ILLINOIS COMMERCE COMMISSION TRANSPORTATION DIVISION / RAIL SAFETY SECTION

Re: DOT #176 624d, Madison St, Waukegan, IL

INSTALL CRTU

WAUKEGAN, ILLINDIS
MADISON STREET
M.P. 35.9
KENDISHA SUBDIVISION
D.O.T.#176 6247

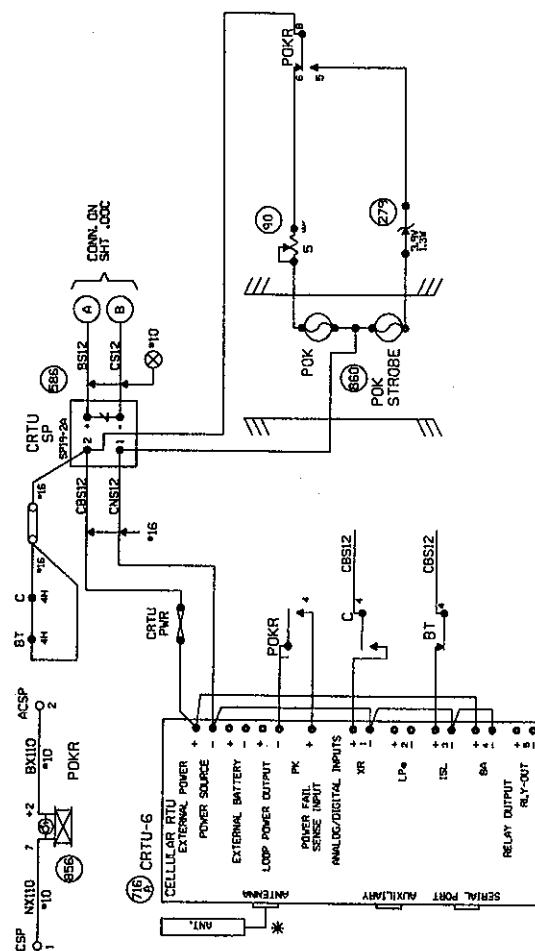
The approaches for this crossing will not meet Fray's 234.225 (in no event shall it provide less than 20 seconds warning time for the normal operation of through trains before the grade crossing is occupied by rail traffic).

Please revise plans showing appropriate approach lengths allowing for FRA's 20 second minimum plus equipment reaction time and train speed variances, or should this crossing be govern by an operating rules please provide our office with a copy of this operating rule.

The rule that covers movement over this crossing, which is on a Yard track in Waukegan, is copied below. This crossing is considered other than main track or siding.
